November 30, 1993 NMP1L 0791

RE: Nine Mile Point Unit 1 Docket No. 50-220 DPR-63

Nine Mile Point Unit 1 Torus Load Reduction Submittal of May 14, 1993 (TAC No. M85003)

LOCAL TORUS SHELL STRESS REGIONS NINE MILE POINT UNIT 1 NUCLEAR STATION

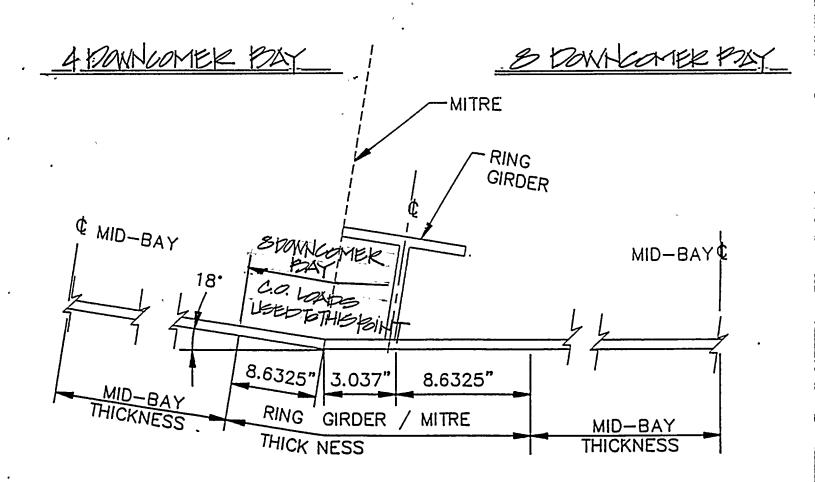
Define the Condensation Oscillation loads to be used for Torus shell evaluation in the vicinity of the ring girder/mitre joint.

Teledyne Engineering Services (TES) Technical Report TR-7353-1 (Reference 1) differentiates between the Condensation Oscillation loads to be used for the free shell evaluations in the four and eight downcomer bays but is silent on the loads to be used for the local region near the ring girder. Should evaluation of the Torus shell in the "immediate vicinity" of the ring girder and mitre joint be necessary in the future, Niagara Mohawk will conservatively use Condensation Oscillation loads associated with the bays containing eight downcomers rather than the four downcomers regardless of whether the evaluation is on the eight downcomer or four downcomer side of the ring girder.

The term "immediate vicinity" will be defined as one-square-root-of-mean radius-times-thickness $(1.0\sqrt{\text{Rt}})$ from the intersection of the ring girder or mitre joint measured longitudinally along the Torus bay. This is the ASME Code definition of a local region caused by a structural discontinuity and is the region used in TR-6801-2 (Reference 2). Attached Figure 1 depicts this region.

The Mark I Containment Program minimum thickness requirements at the midbay (free-shell) location of the torus shell are governed by the primary membrane stress (P_M) obtained from the one-fortieth Stardyne model considering the various Mark I Containment Program event combinations. For the Torus shell adjacent to the ring girder (local shell), a gross structural discontinuity, the minimum thickness requirements are governed by the primary local stress (P_L). The primary local stress region extends for a distance of 8.6325 inches or $1.0 \sqrt{Rt}$ from the intersection of the ring girder longitudinally along the eight downcomer torus bays. In addition, on the mitre side of the ring girder, i.e., the bays containing four downcomers, the local region extends 8.6325 inches beyond the mitre away from the ring girder. The remainder of the Torus shell is governed by the midbay thickness requirements.
